**MONTGOMERY COUNTY PLANNING DEPARTMENT**  
THE MARYLAND-NATIONAL CAPITAL PARK AND PLANNING COMMISSION

**REVIEW TYPE:** Preliminary Plan of Subdivision

**PROJECT NAME:** Avery Lodge

**CASE #:** 120070360

# PRELIMINARY PLAN

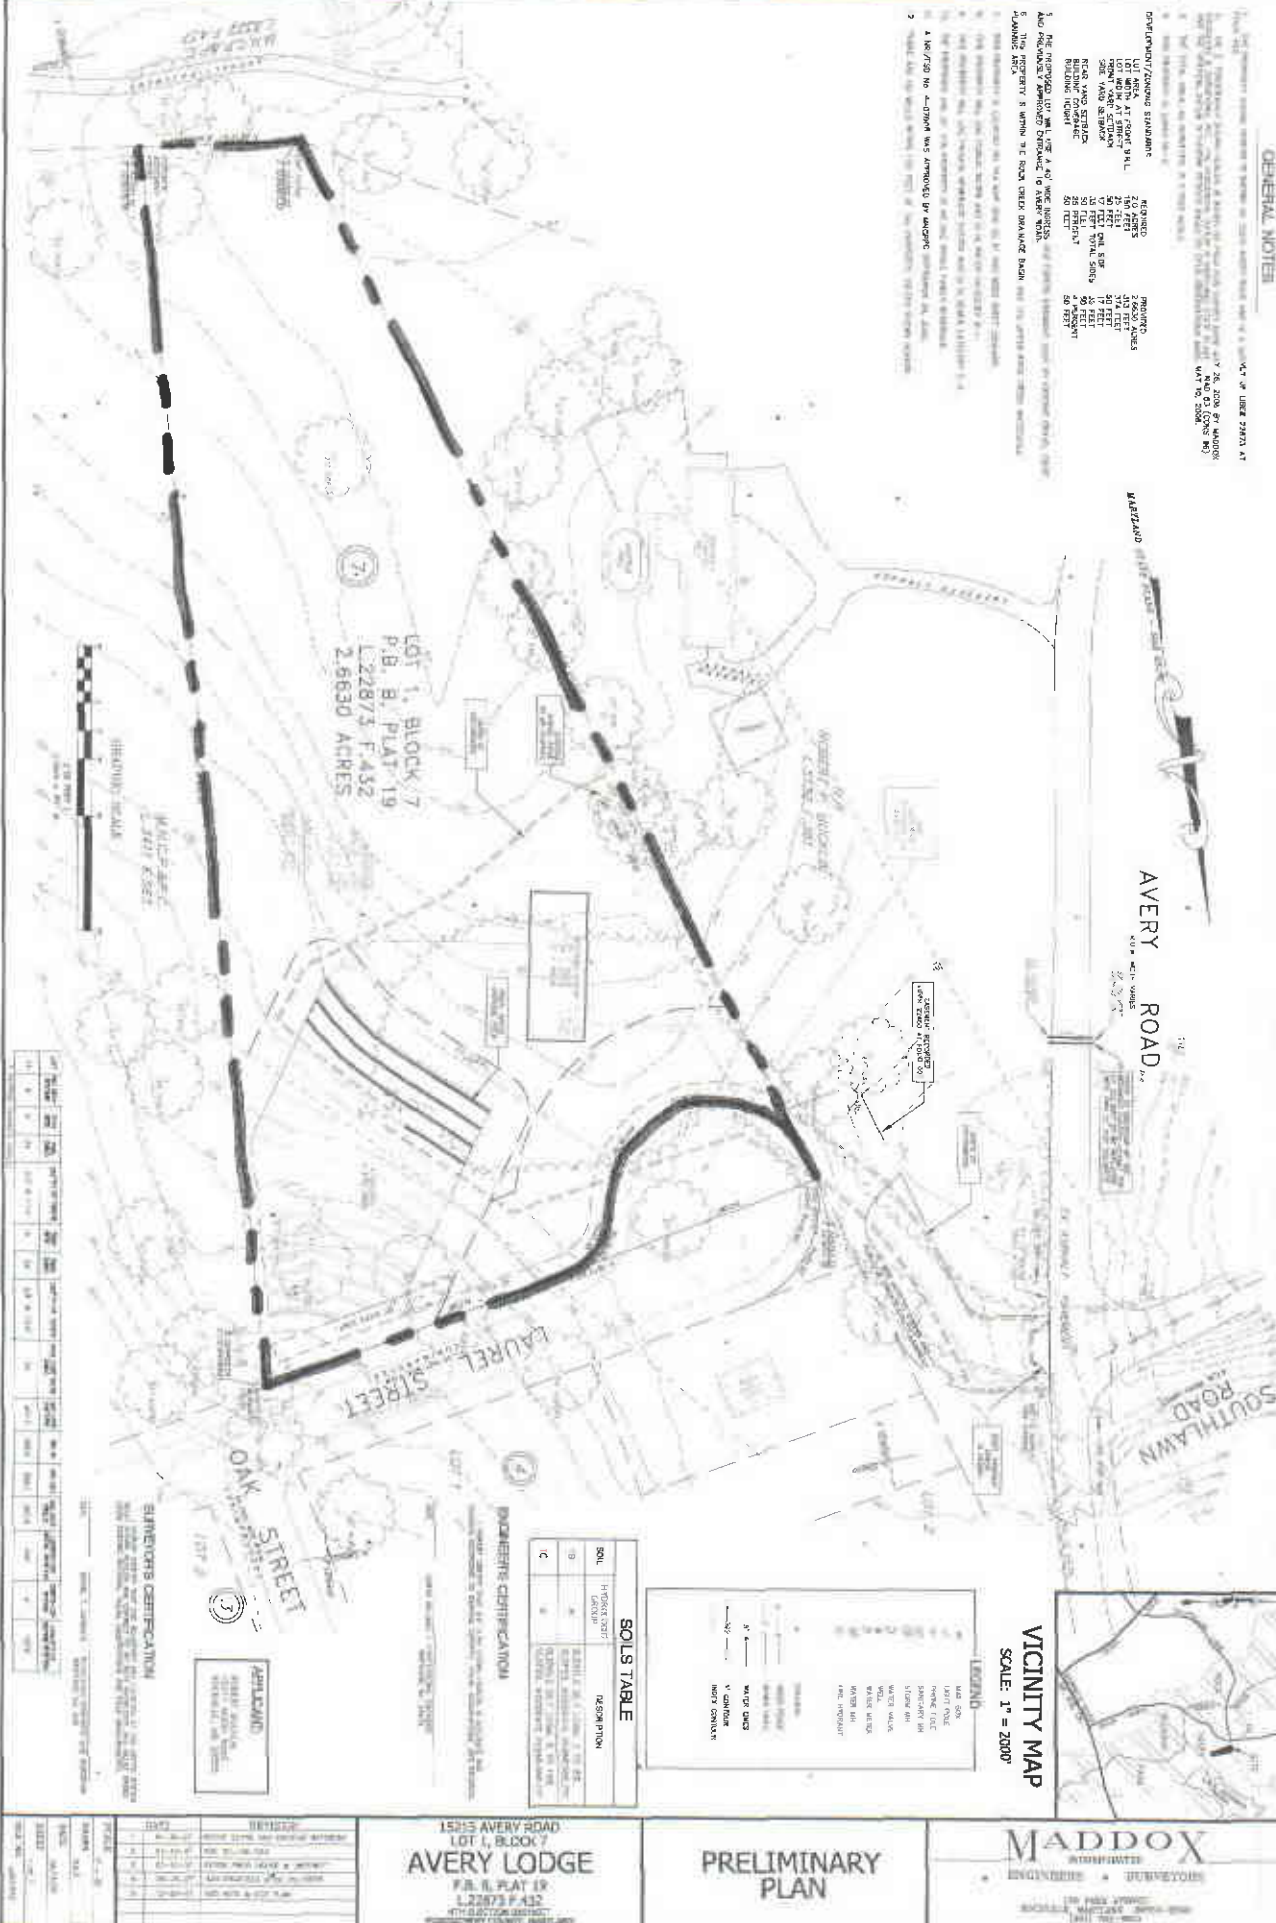
- 3) The record plat must provide for dedication of approximately 5,641 square feet of right-of-way for unimproved Laurel Street as shown on the preliminary plan.

The applicant proposes to record the property as 1 lot to accommodate 1 residential dwelling unit. The proposed lot will be 2.66 acres after dedication for Laurel Street is made. A gravel driveway exists on the property and is to be removed. Access is proposed from Avery Road via a private driveway. The applicant owns the adjacent property (Parcel 336) directly west of the Subject Property and has recorded a 40 foot-wide ingress/egress and utilities easement on Parcel 336 to allow for adequate access to the Subject Property. This easement is shown on the preliminary plan. The dwelling unit will be served by public water and a private standard septic system.

The proposed lot does not generate 30 or more vehicle trips during the morning or evening peak-hours. Therefore, the application is not subject to Local Area Transportation Review. Laurel Street is a tertiary street, requiring 50 feet of right-of-way. The applicant proposes to dedicate approximately 5,641 square feet of additional right-of-way for a future cul-de-sac bulb for unimproved Laurel Street. Proposed vehicle and pedestrian access for the subdivision will be safe and adequate with the proposed public and private improvements.

The applicant submitted a Preliminary Forest Conservation Plan with the Preliminary Plan of subdivision. There are 2.60-acres of existing forest on the Property. The applicant is proposing to remove 1.05 acres and retain 1.55 acres. In order to provide proper access to the Property, 0.05-acres of off-site forest will be cleared from the adjacent property to the west. All forest retained is contiguous and leaves the proposed residence a significant useable yard. The proposed forest retention satisfies the requirements of the Forest Conservation Law.
